Town of Rolesville, NC
Department of Planning

Comments on #SDP-26-0008 - Planning & Zoning: Site Development Plan

Application Number: #SDP-26-0008
Application Type: Site Development Plan
Date: July 24, 2026
Address: 408 E YOUNG ST, ROLESVILLE, NC 27571
Parcel: 1768098727

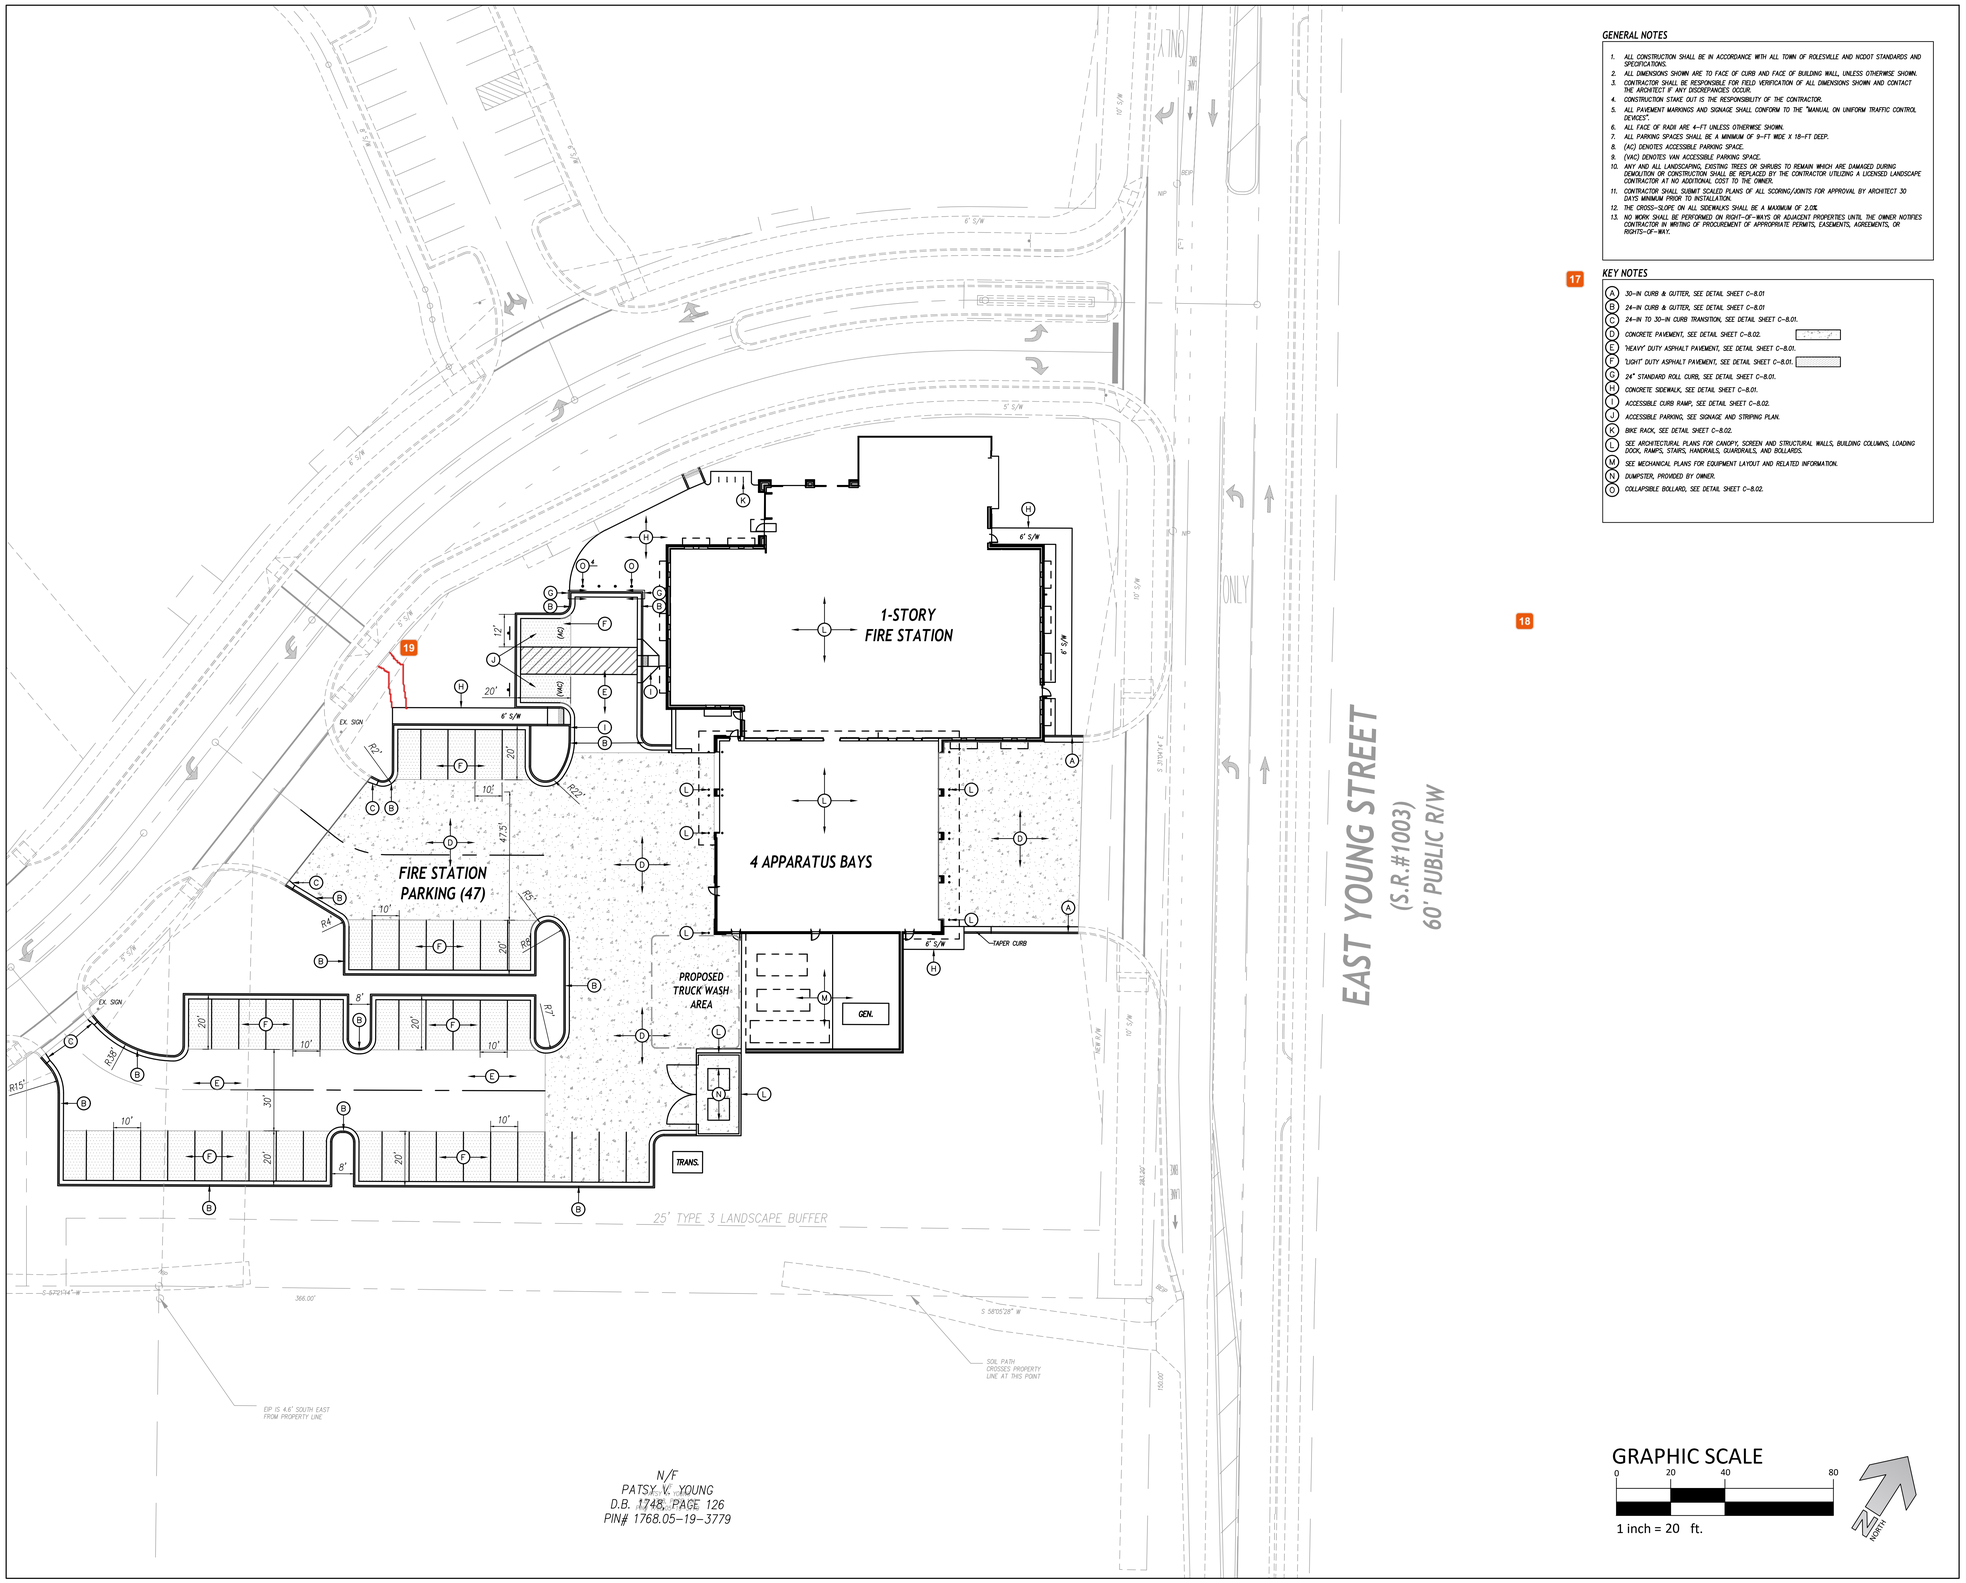
3 **Austin Bain**
Submit to Energov for COR review. Include the COR review number on cover sheet. Include the Rolesville review in the details on Energov for cross reference.

4 **Michele Raby**
Lot 2? Is there an addressing plan? Have you contacted WC E-911 for addressing?

5 **Stephen Wolf**
** Plans are preliminary and not for construction. The address listed is for the entire site. Please provide Wake County GIS approved address when building plans are submitted.

8 **Meredith Gruber**
A Site Development Plan should include a Site Plan as the central plan for the set.

9 **Meredith Gruber**
Let's schedule a meeting to go through any questions your team has about recently approved text amendments.

10 **Michele Raby**
Please add a lighting plan.

11 **Michele Raby**
PIN1768098727 is only for 408 E Young. Please add PIN1769102240 for 406 E Young.

12 **Michael Elabarger**
The application form indicates a Site Area of 2.5 acres, but the Site Data table on the Cover Sheet (Sheet C-0.00) lists the Deeded Acreage as 13.78 acres and the Disturbed Area as 2.5 acres. Please update the 'Site Area (In Acres)' field on the application form to reflect the total deeded acreage of the parcel.

13 **Michele Raby**
Please add impervious calculations, open space calculations, building height information.

15 **Meredith Gruber**
See LDO Section 6.2.2.1. Perimeter Buffers, and verify you are looking at the latest version of the LDO dated June 16, 2026. The latest version includes updates as per TA-26-0005 Omnibus Text Amendments--many of these amendments were made to support the Town Campus project. Type 3 Perimeter Buffers require a minimum opacity of 75% up to 6'. This may be achieved with plant material only or a combination of plant material and a wall. At least 50% of plant material shall be evergreen.

16 **Michele Raby**
Please add previous entitlements as shown on the cover sheet example: https://www.rolesvillenc.gov/sites/default/files/uploads/site-development-plans-sdp-non-res-cover-sheet-example.pdf

SHEET NUMBER:
C-1.01

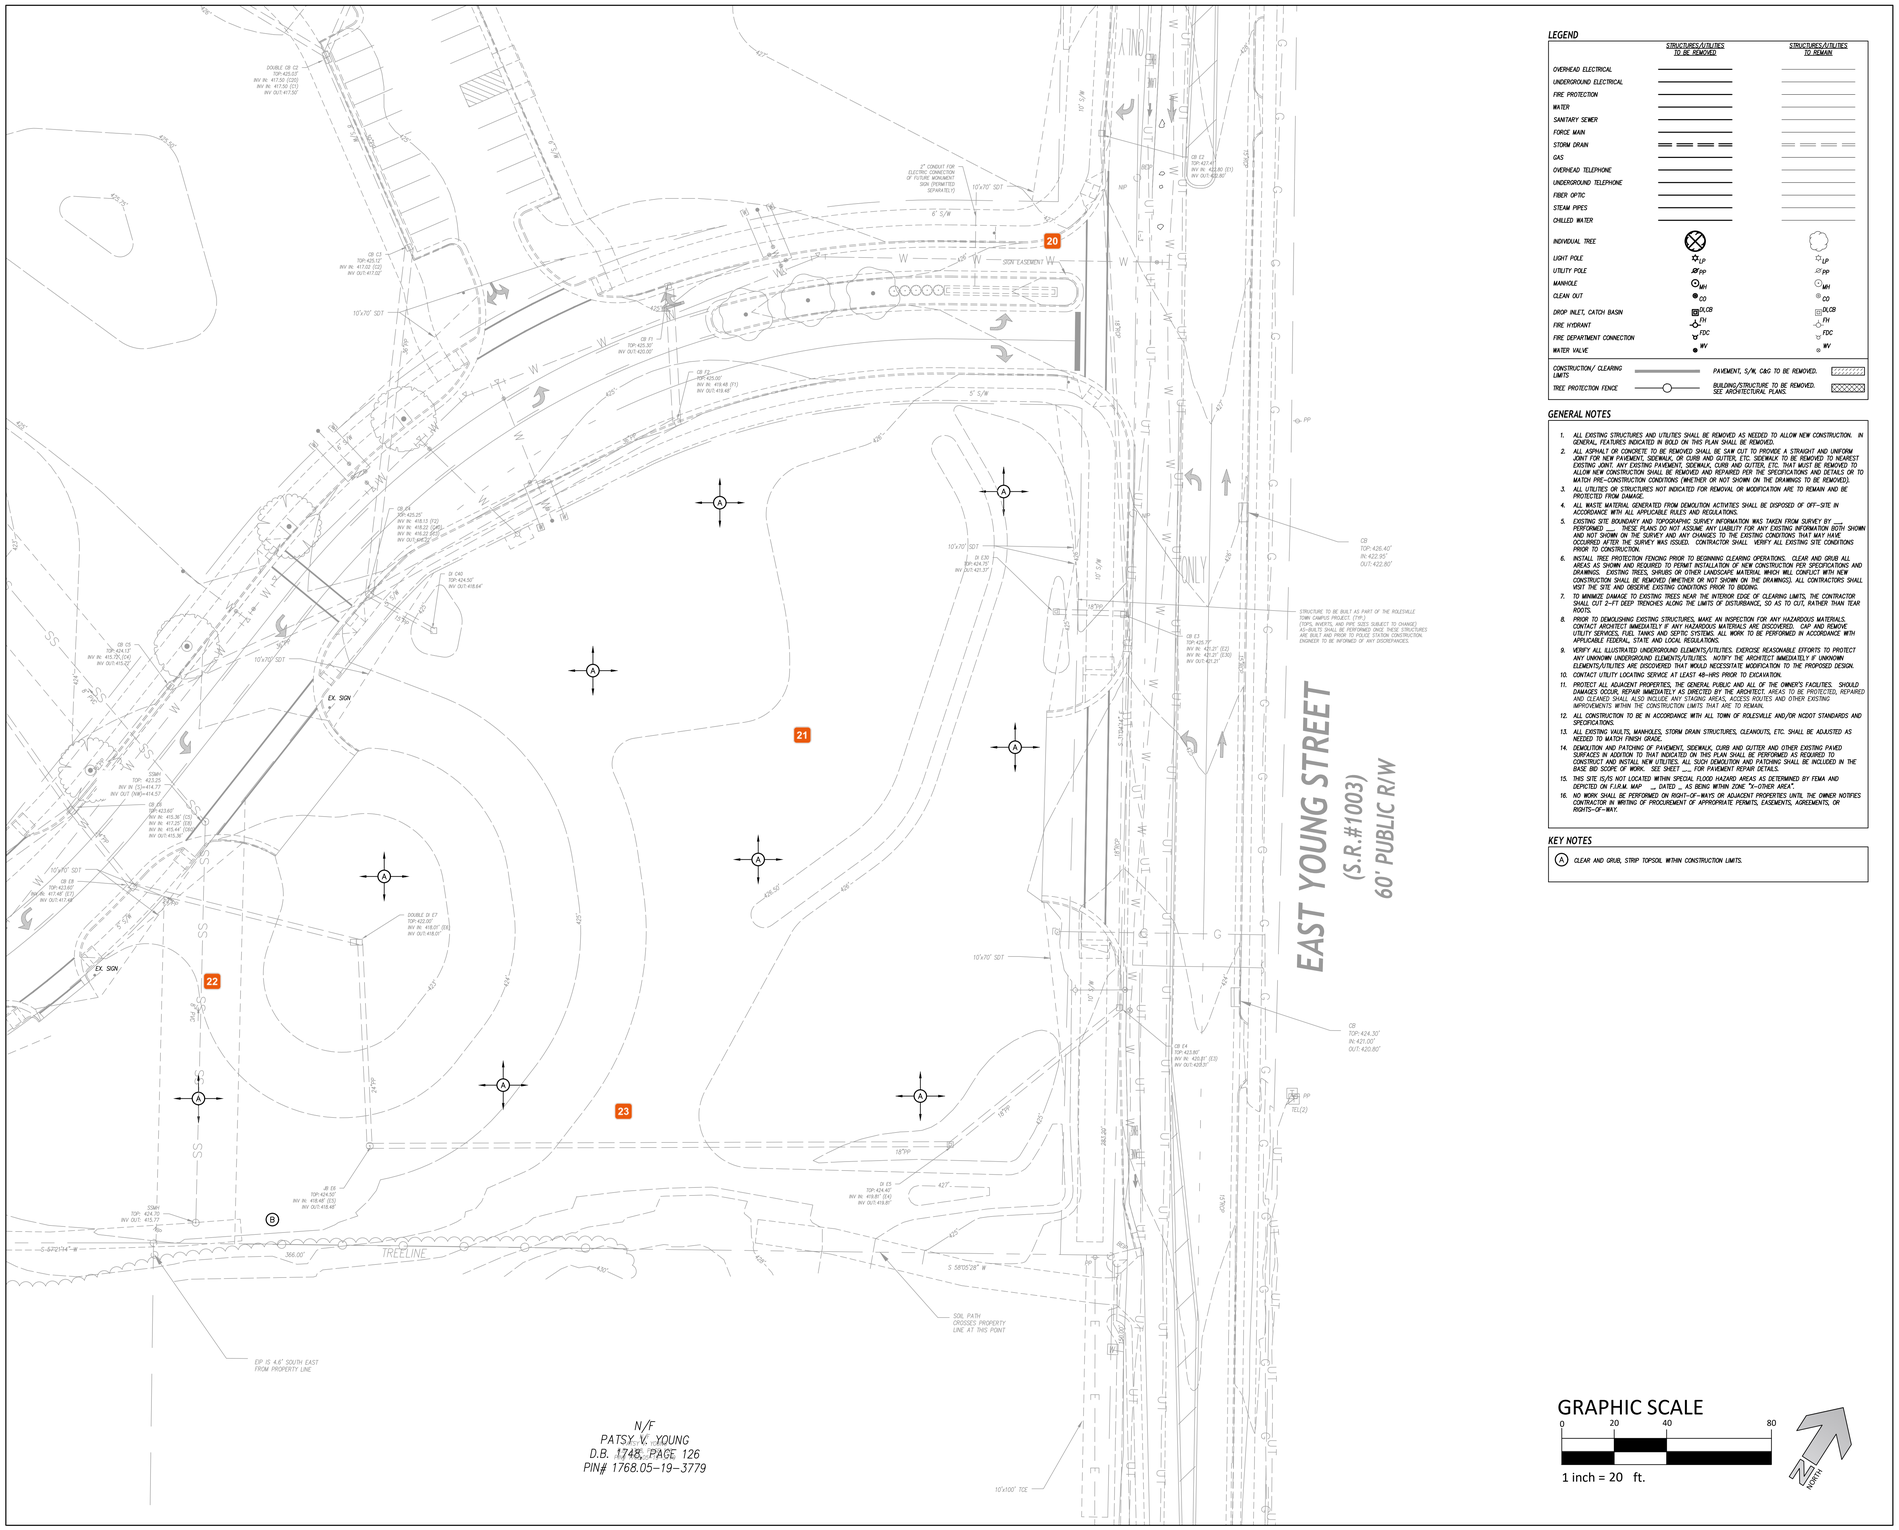
17 **Jacqueline Thompson**
Please identify if spill curb will be used since a detail is included.

18 **Jacqueline Thompson**
Please show and label a defined property line and the required setbacks and buffers.

19 **Jacqueline Thompson**
Consider a sidewalk connection for convenient access to the larger network.

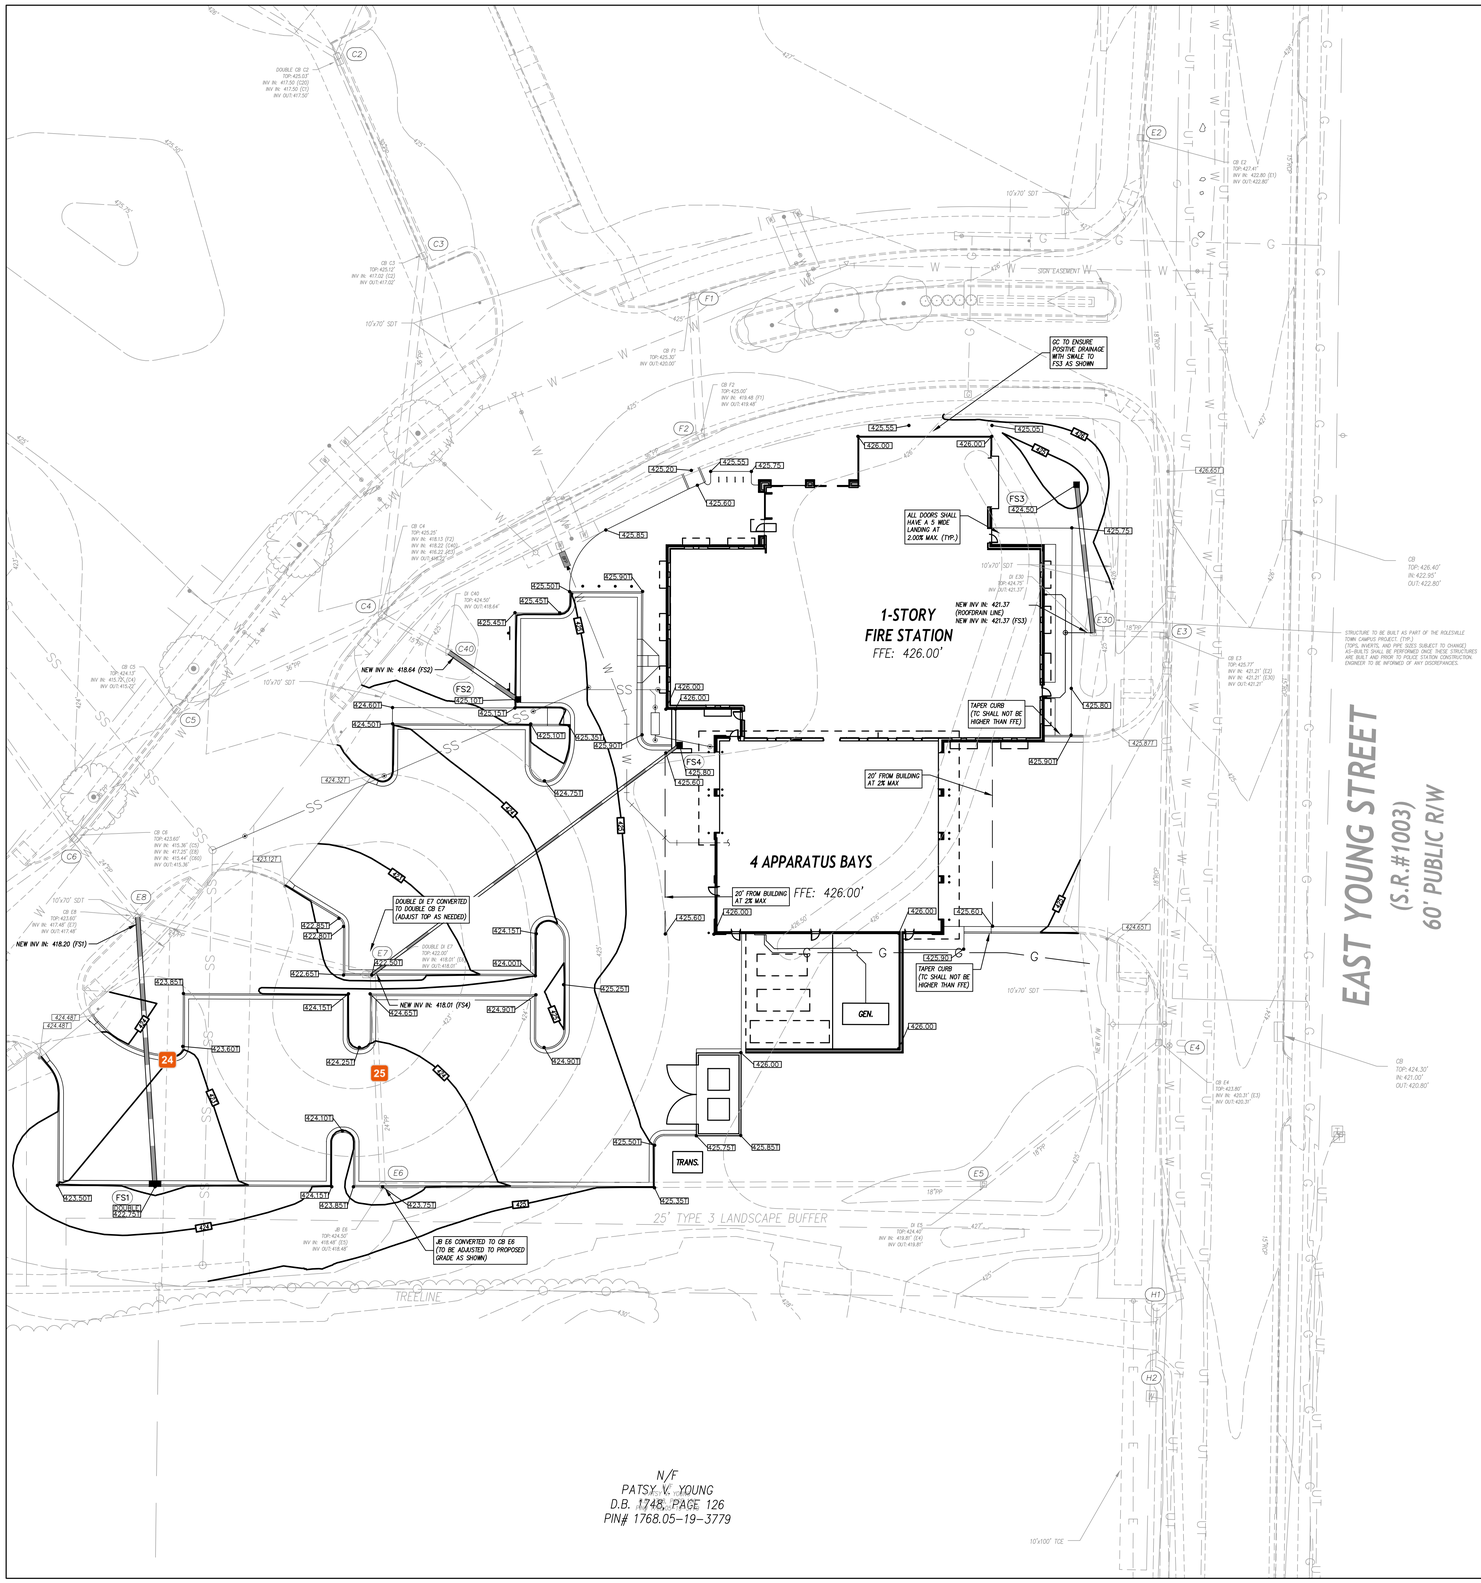
22 **Jacqueline Thompson**
Please label all easements

23 **Jacqueline Thompson**
Confirm if this existing storm system has an easement.
